CLARIFICATION OF A RECENT COMPARISON OF NATURAL CIRCULATION FLOWS IN  
"CODE VALIDATION AND UNCERTAINTIES IN SYSTEM THERMAL HYDRAULICS" BY F.  
D'AURIA AND G.M. GALASSI

Recently, a quantitative comparison of the effectiveness of natural circulation flows in the CANDU type RD-14M facility and integral facilities simulating PWR and WWER geometries was published (D'Auria and Galassi (1998)). The RD-14M data presented in this comparison was inappropriately extracted and interpreted from an early paper for test T8802 (Ingham et al (1991)). The authors of this comparison incorrectly assumed the core flow for the RD-14M test was equivalent to the reported flow through only one of the steam generators. Because of the figure-of-eight configuration, this assumption is a factor of two too low under strictly unidirectional flow conditions. The error in this assumption becomes even greater following the onset of channel flow reversal. The RD-14M experimental data used is not consistent with the author's analysis methodology. As a consequence, the magnitudes of RD-14M natural circulation flows are severely underestimated.

Figure 1: Comparison of above header and total core flow in RD-14M

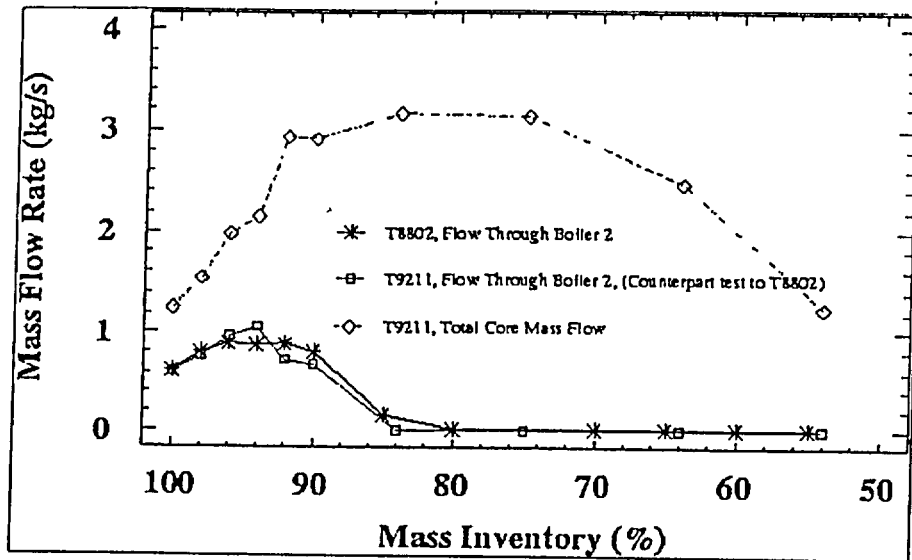
Core mass flow rates for the RD-14M test used in this comparison, T8802, cannot be calculated due to insufficient instrumentation in this early test. However, a more recent, better instrumented test, T9211, was conducted at the same nominal conditions as T8802. Test T9211 was the only test conducted using similar conditions and test procedure. Experimental results for T9211 are comparable to T8802 as shown in Figure 1. The similarity between these two tests is also illustrated in Table 1 where initial conditions, boundary conditions and key experimental results are compared. Important results to note include the similarity of inventory for the first and second flow reversals, breakdown of flow through the boilers and break down of flow in one of the channels (dry out).

The core mass flow rate is obtained by adding the mass flow rate through each channel. Individual channel mass flows are determined by correcting single-phase inflow feeder flow rate measurements made at steady-state conditions at each inventory for density.

To make an accurate comparison of RD-14M with other facilities, the total core mass flow as shown in Figure 1 should have been used by D'Auria and Galassi (1998) instead of the flow through only one of the steam generators. As illustrated in Figure 1, both the effective range and the magnitude of the core mass flow rates are significantly larger than the values used in assessing RD-14M results. The referenced comparison implies significant core flow rates only occur over a narrow range of primary inventories (82 to 100%), whereas in reality effective core flow rates were measured at inventories as low as 48%. Similarly, the actual maximum core mass flow rate is a factor of three higher than that in the data used in the referenced comparison.
